STAFF RECOMMENDATION

NCPC File No. 6479

SMITHSONIAN INSTITUTION
PATENT OFFICE BUILDING – COURTYARD LANDSCAPE
G, F, 7th, and 9th Streets, NW, Washington, D.C.

June 29, 2006

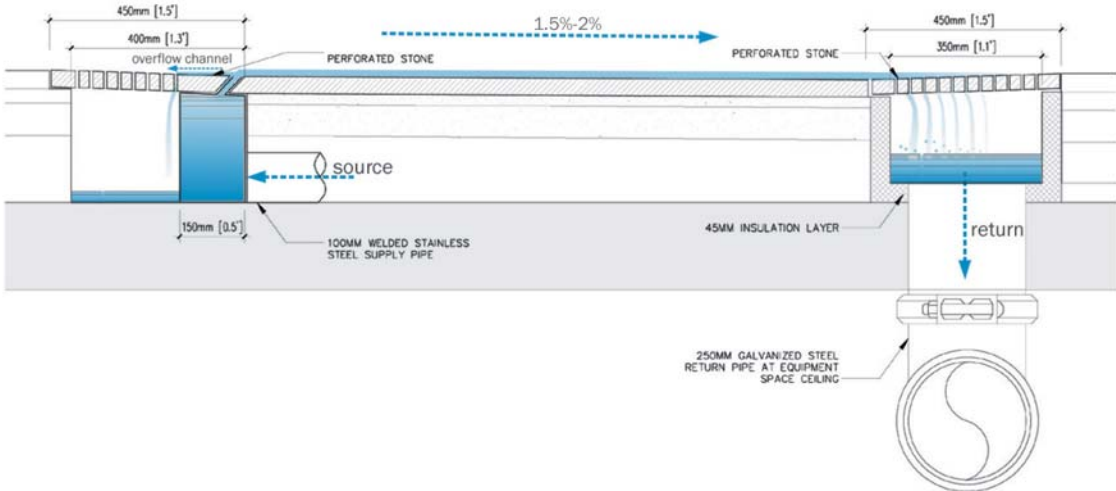
The proposed landscape plan for the courtyard responds to the Commission Action at the April 2006 meeting and to Commissioners' comments at that and previous meetings. The Commission's primary objective in the past year has been to ensure that the courtyard be designed to appear and function as a public amenity for all visitors to this significant historic public building.

The water scrim has been softened to be a more complementary element within the historic courtyard facades. The removal of the catering benches reinforces the primary identity and function of the courtyard as a public amenity. The simplification and increased openness of the planting plan, especially the removal of the tree sub-canopy layer, allows for improved views across the courtyard of the courtyard facades. The water scrim will reflect the canopy and sky, and plantings will soften the broad extent of the granite floor and create vertical scale-giving elements in the courtyard. The design provides trees, plants, water, and natural light within the courtyard.

- The catering benches have been removed. Catering equipment will be stored elsewhere and set up in the courtyard when needed for an event.
- The water scrim is in the same location within the courtyard. It has been shortened slightly at either end (a little over 4 feet) so that it does not extend to the east and west courtyard facades. The metal grates running along both long edges of the scrim have been removed to soften its linearity. The water will circulate through perforated granite pavers.

- The overall floor pattern has been simplified so that there are fewer changes from the light to dark granite. The paving stones themselves have been redesigned. The previous plan showed square stones set on the diagonal. The current plan shows smaller stones of random and varied dimension, set in linear fashion in north-south rows.

- The planting plan for the planter/benches in the courtyard has been simplified, with the removal of the sub-canopy tree layer. The plant palette, designed in coordination with the Smithsonian Horticulture Division, was selected to be suitable for the environment of the courtyard and for anticipated maintenance levels. Two majestic trees are proposed for either side of the south apse—*Ficus rugibinosa* or *Ficus nitida* are being considered. For the canopy level, *Bucida buceras* (“Shady Lady”), planted 20 feet high, would provide a light evergreen cover. Below the tree level, layers of shrubs and groundcovers, including ferns, are proposed.

Water Scrim, detailed with perforated stone edges for water source and return.

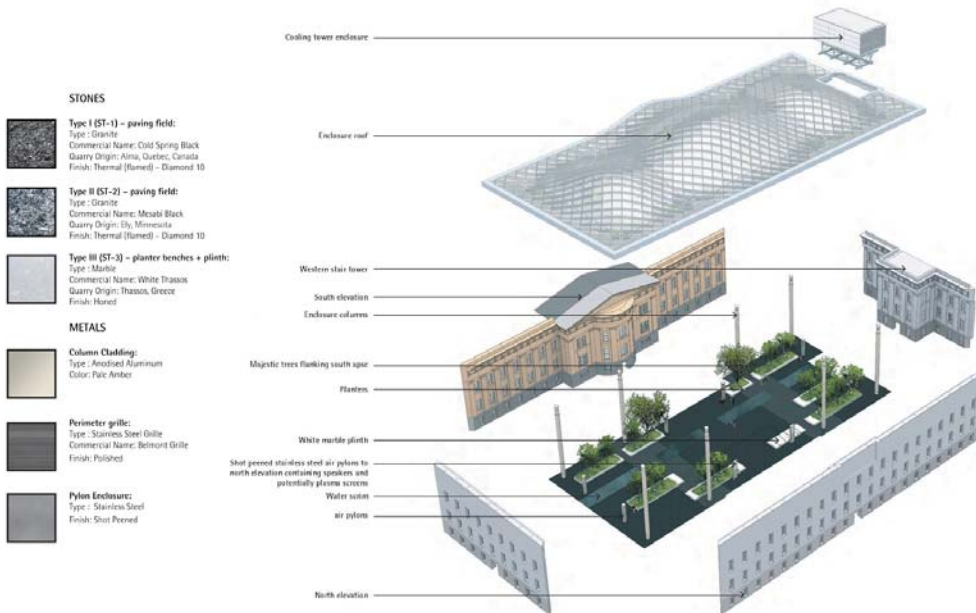
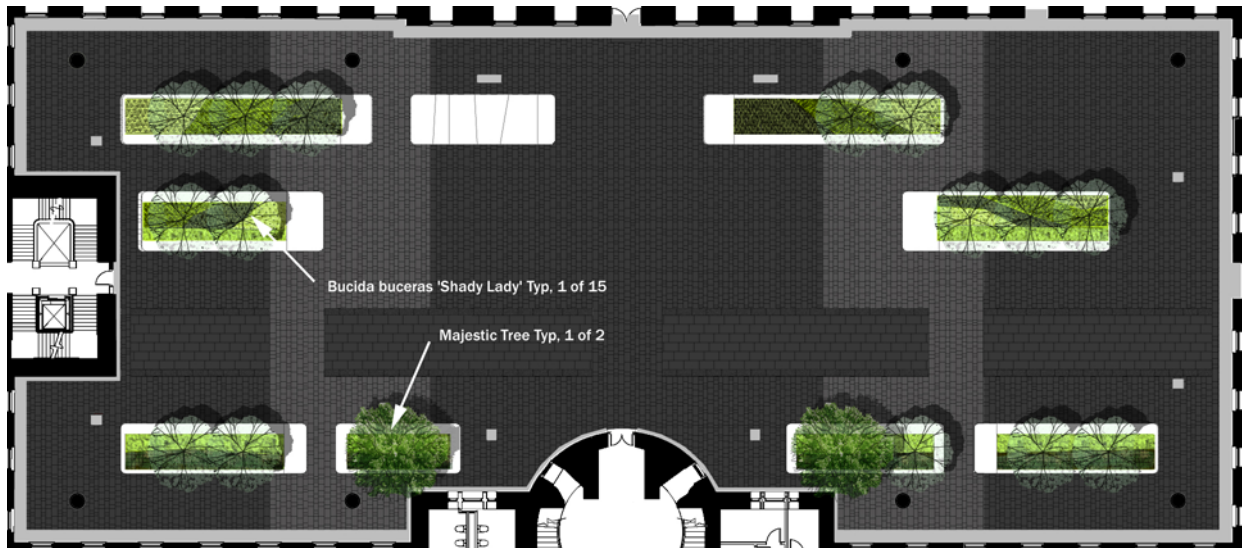
Recommends that the water scrim be redesigned to be more responsive to the “design character and setting” of the courtyard as a central gathering space, softening the scrim’s dominant linearity across the courtyard floor in order to improve its compatibility with the courtyard facades and spatial proportions.
